MEMORANDUM

TO:	Planning Commission Members
FROM:	Michael A. Lumbis, Planning and Community Development Director
PRIMARY REVIEWER:	Jennifer L. Voss
SUBJECT:	Site Plan Approval – 848 Ives Street
DATE:	March 28, 2024
Request:	Site Plan Approval to construct a 1,950 SF storage building and 20-foot-wide asphalt driveway at 848 Ives Street, Parcel Number 14-49-118.000 .
Applicant:	Kayla Kibling, Engineer, Barton and Loguidice D.P.C. on behalf of Ives Hill Country Club 465, LLC
Proposed Use:	Storage for Golf Course Operations
Property Owners:	Ives Hill Country Club 465, LLC

IVES HILL COUNTRY CLUB 465, LLC PROPOSED STORAGE BUILDING

SITE PLAN APPROVAL SET

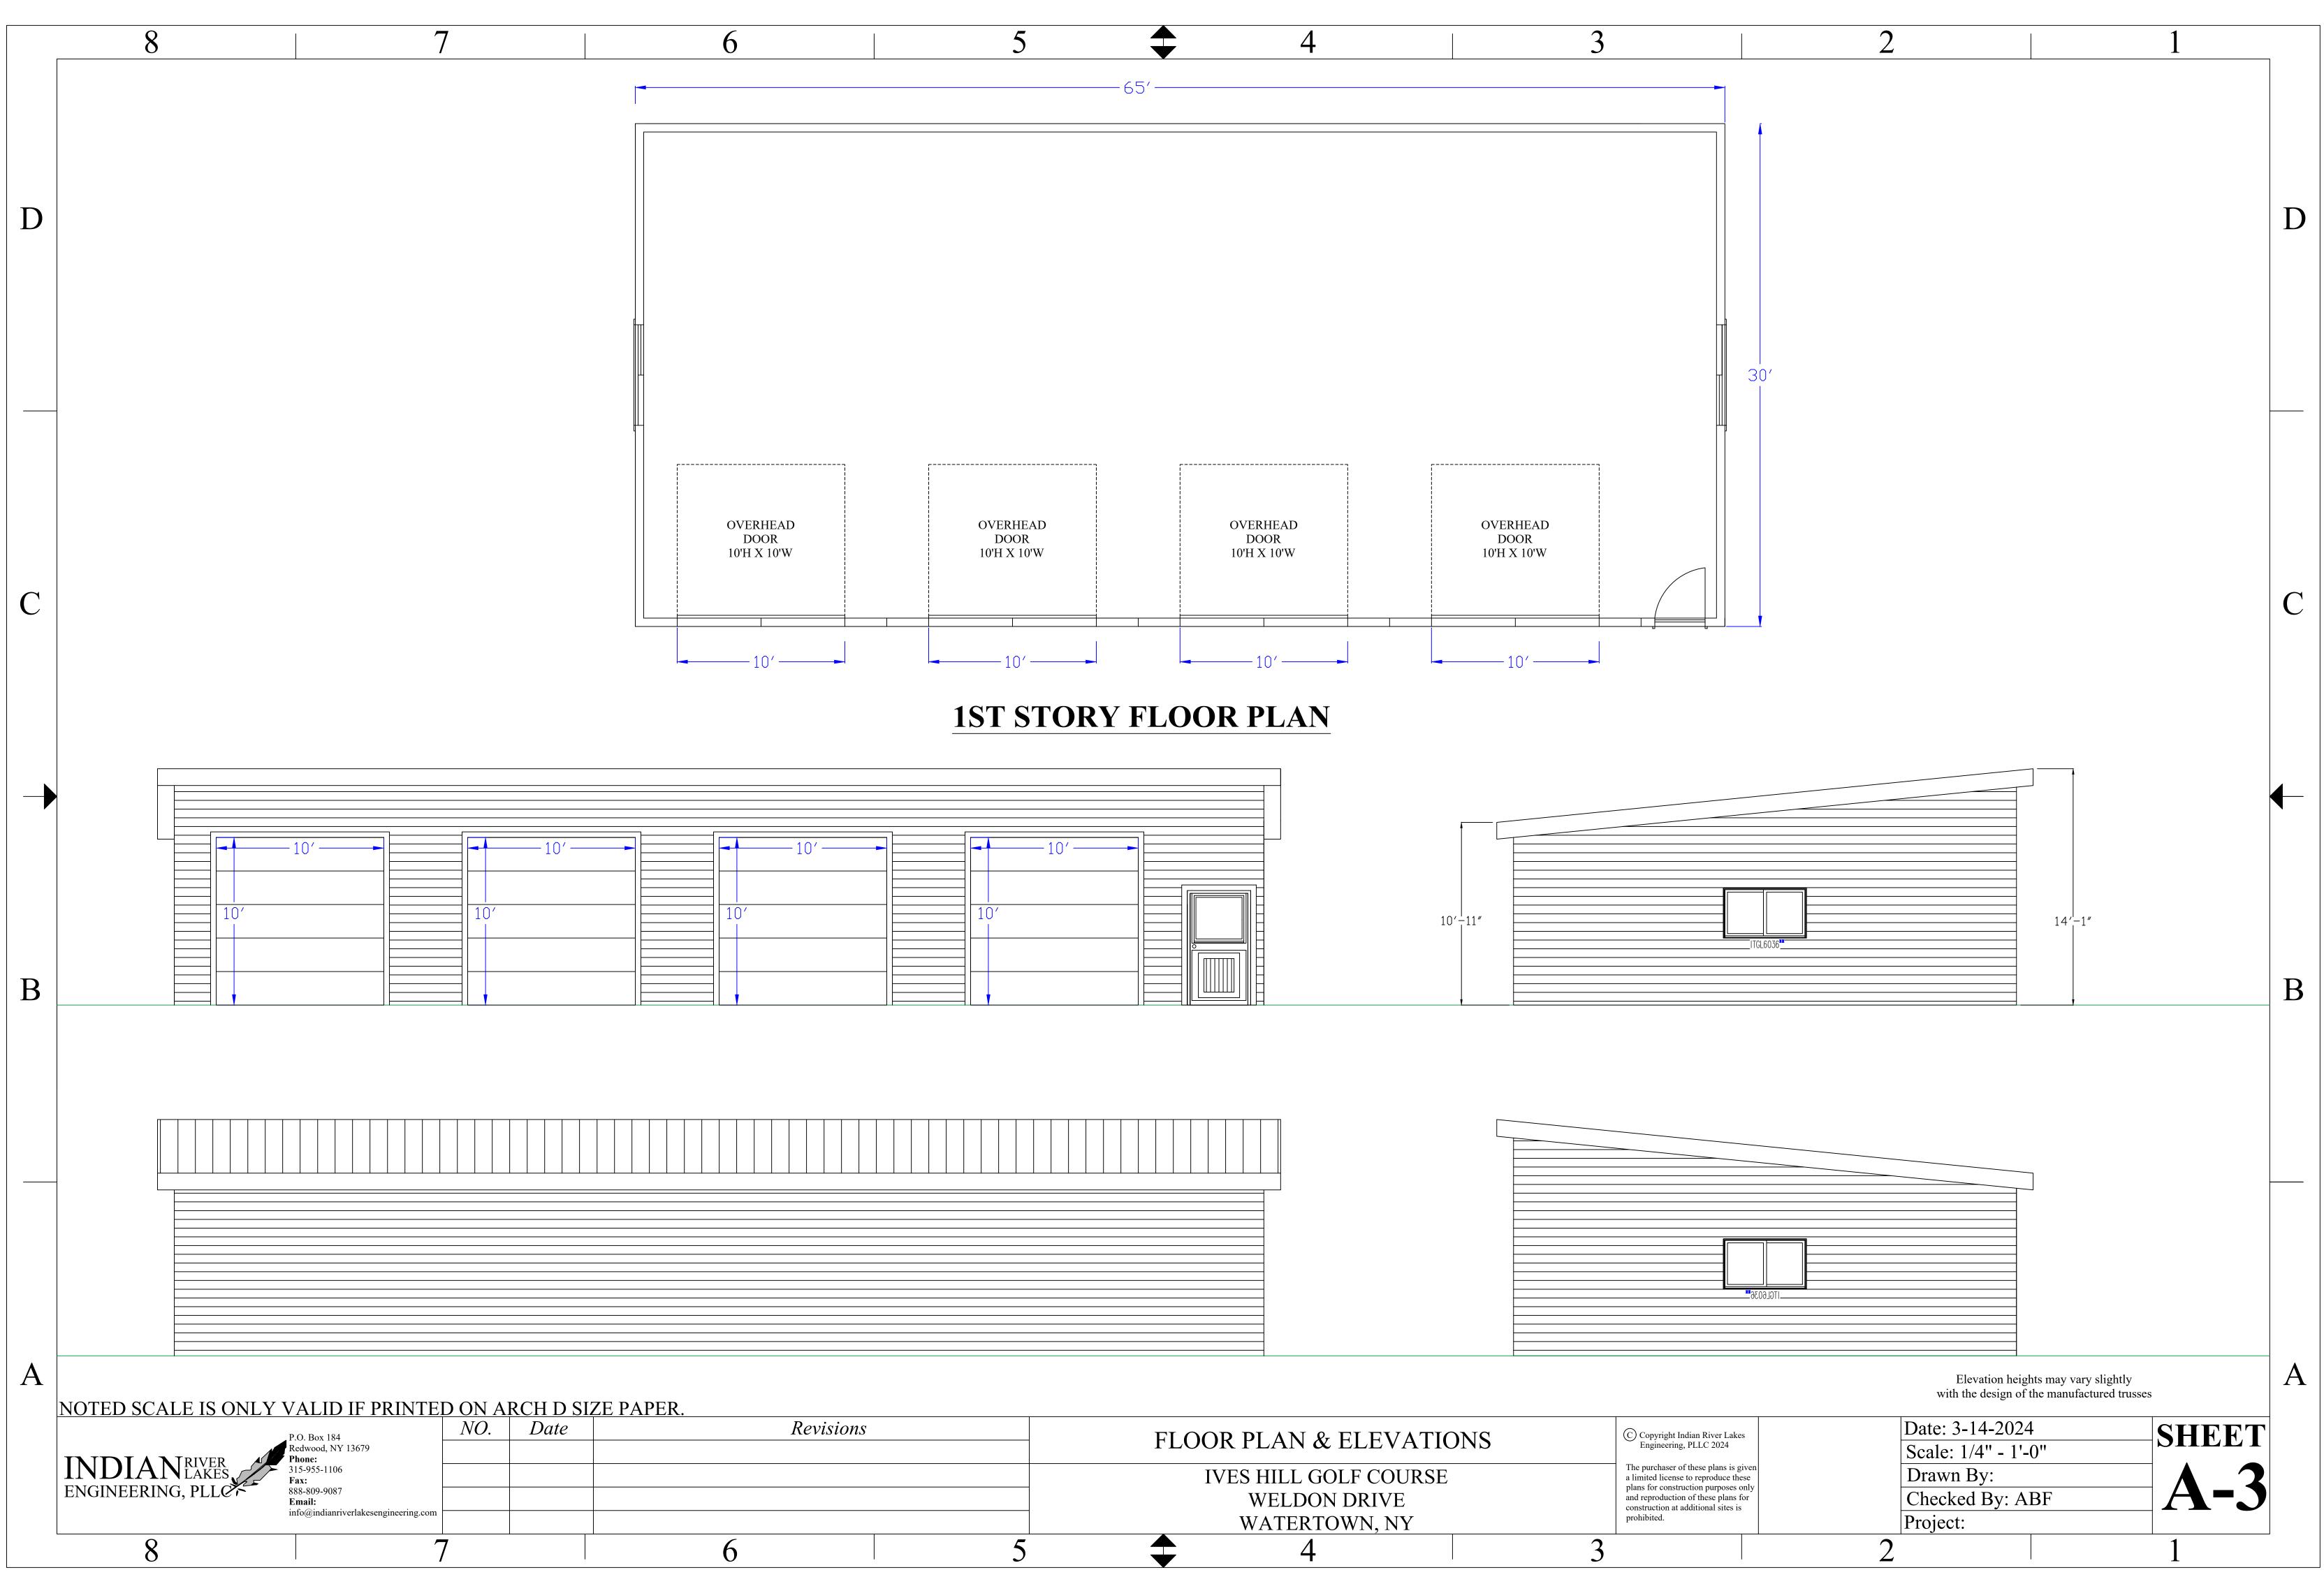
Per Section 310-83, Side and Rear Yard Landscaping, of the City's Zoning Ordinance, a side yard landscaped strip shall be provided that is at least ten (10') feet wide between the storage building and the townhouses. The proposed width on the plans is 44', however, no new landscaping is proposed and the existing trees are expected to require removal due to their condition The applicant will be required to provide and plant a minimum of one (1) large deciduous tree (2" DBH minimum) every forty (40) linear feet or one (1) small to medium deciduous tree (1.5" DBH minimum) every twenty (20) linear feet. Planting beds with shrubs, perennials, and/or annuals are recommended between trees.

Stormwater and Drainage: The applicant should be aware of the existing manhole and catch basins adjacent to where the proposed driveway will be constructed and ensure they will not be covered up during or as a result of construction.

Utilities: The Engineering Department requires that all existing utilities be displayed on the design plans. There is a sanitary sewer line that runs underneath where the driveway is proposed. Information on how much cover is being provided over this line must be submitted to the City Engineering Department.

- 2. The applicant shall provide a landscape strip/buffer zone a minimum of ten (10) feet in width between the building and the townhouses, that meets the landscape requirements contained within the Zoning Ordinance.

- 3. Information must be provided to the City Engineering Department regarding roof drainage, and the proposed cover over the existing sanitary line.
- 4. The Planning Commission must complete Part 2 of the Short EAF and reach a determination pursuant to SEQRA.

Revisions	FLOOR PLAN & ELEVATIONS	($\tilde{(}$
	IVES HILL GOLF COURSE] a	Т а
	WELDON DRIVE	F a c	p a c
	WATERTOWN, NY	F	p
5	4	3

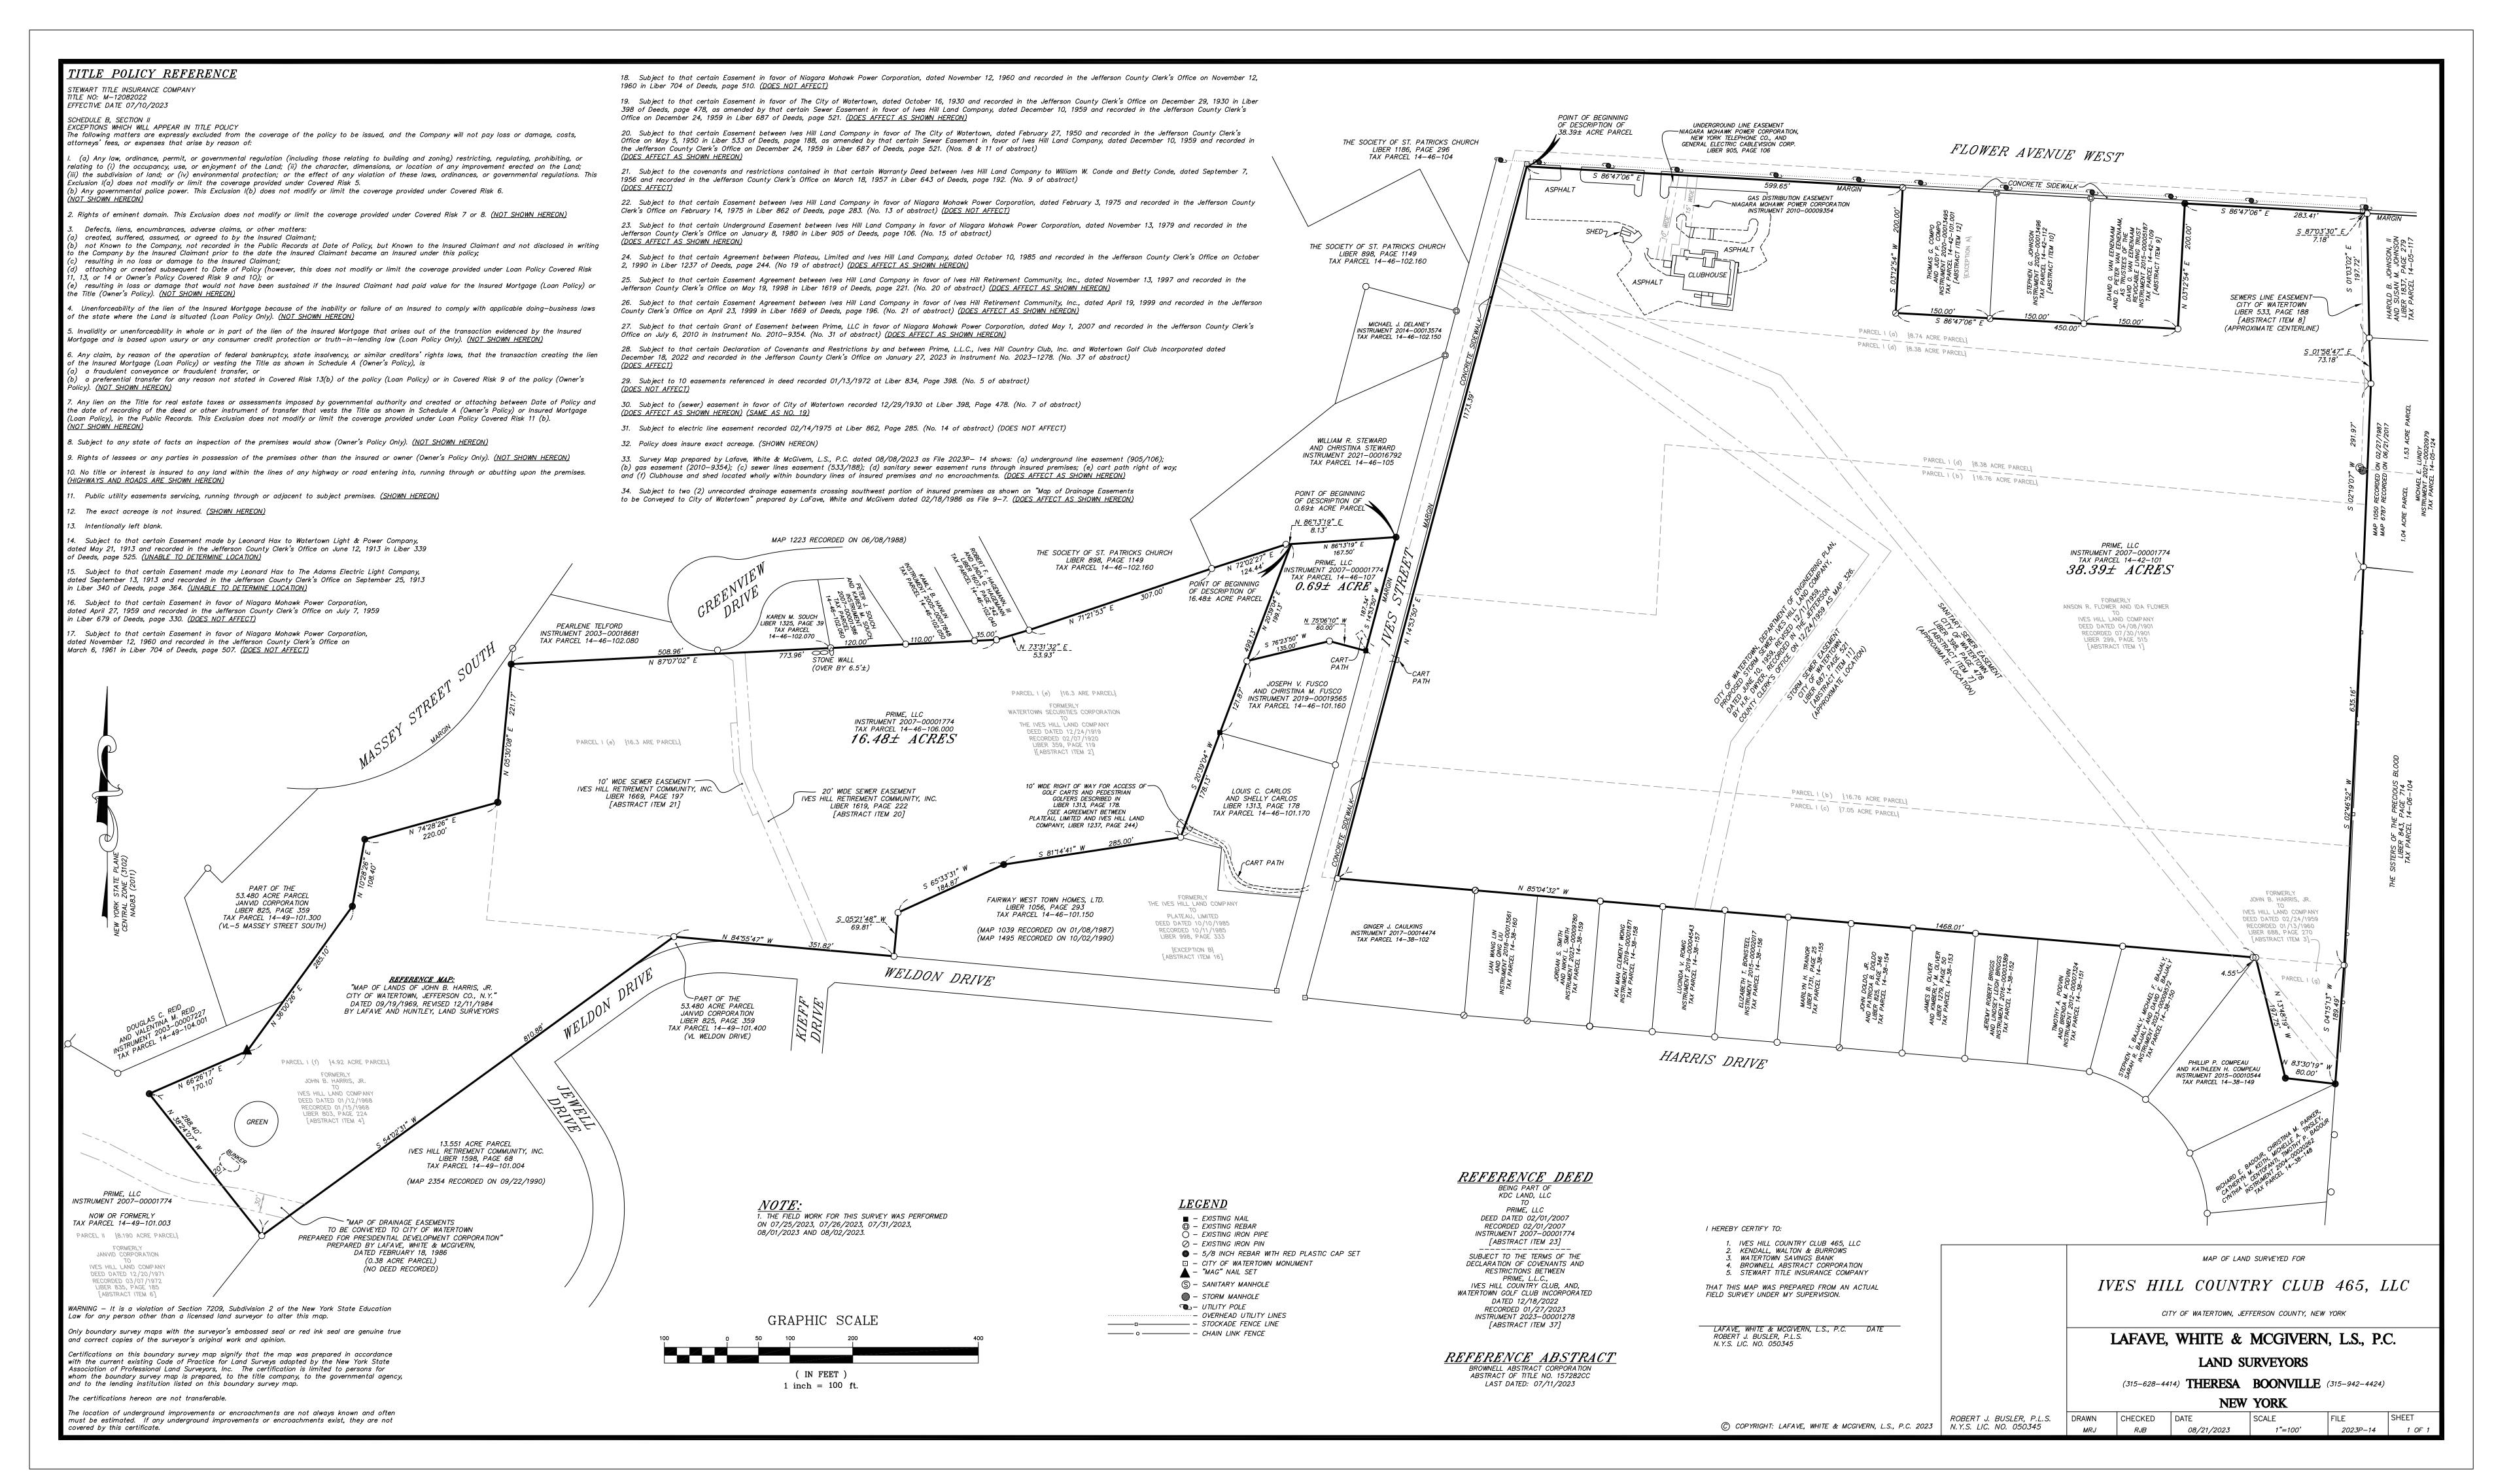
The original drawings submitted included one very small window on the front of the building facing Weldon Drive. The Residential District requires a minimum ground floor transparency of 30% and it was clear from the drawings that the transparency requirements were not being met. After a follow up discussion with the applicant, a revised elevation drawing was submitted that shows a 12.25' x 10' window on the front of the building, in order to meet transparency requirements.
